# **ARINC 424 NDB**

**Draft 1 of Supplement 24  
Discussion**

## **AF LEG BASED ON NON-COLLOCATED NAVAIDS**

<b>SUMMARY</b>
Discuss if there are any additional information that needs to be added to support the AF leg recommended navaid changes that were made in the ARINC Specification 424-23

The following procedure is an example where the AF leg is defined as an arc from a ILS DME. The procedure is the CYLW LOC Y RWY 16. The NDB and IDME are 1.39nm apart.

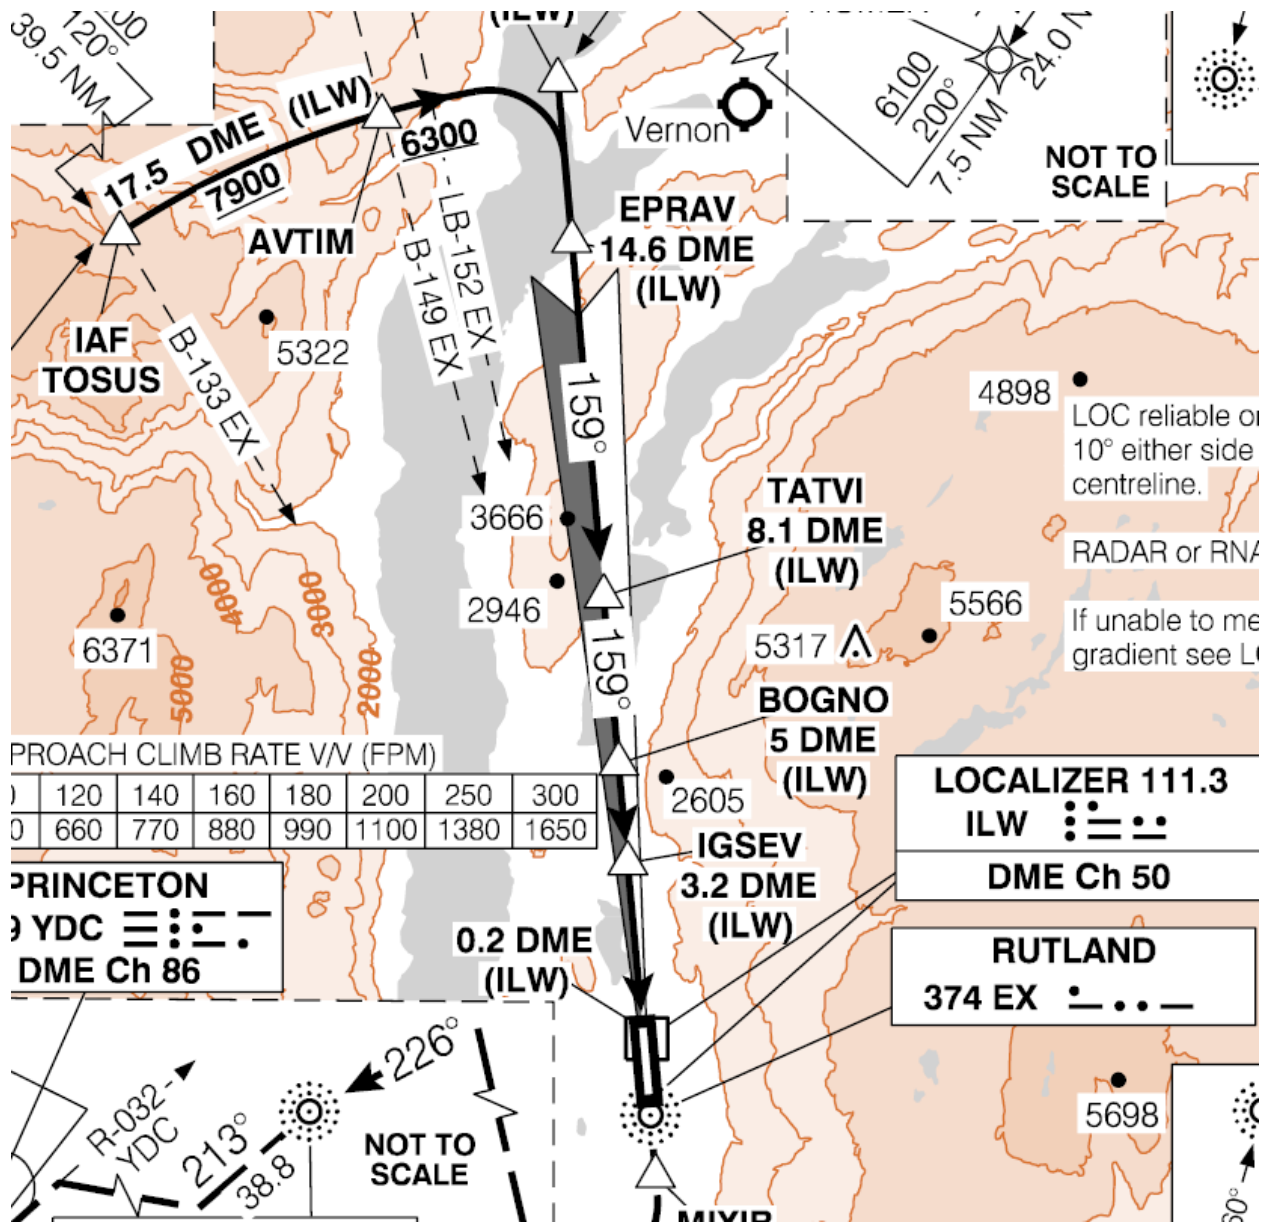
In the above procedure, the source provided bearings of 133 and 149 are to the EX NDB and not referenced to the ILW DME.

1. If the navaid providing the bearing information for the AF leg in the source document is not collocated with the DME source for the AF leg, is it expected that the data supplier will recalculate the bearings from the DME source, to include in the Mag Crs and Theta fields?
  - a. For example, in the above procedure, would the bearings from the NDB get replace by bearings from the ILW DME to the TOSUS and AVTIM fixes respectively. The Mag Crs would be 311 and the Theta would be 328 (using airport mag var).
2. Are the Mag Crs and Theta fields actually used for AF legs? Or is the system just intercepting the arc?
3. What Mag Var should the data houses use for DME recommended navaids.

**3.4.6 When an AF leg is based on a DME or IDME, and the Boundary Radial and Fix Radial are originating from a different non-collocated navaid, the Radials must be derived from the DME or IDME to correspond with the procedure source intent.**
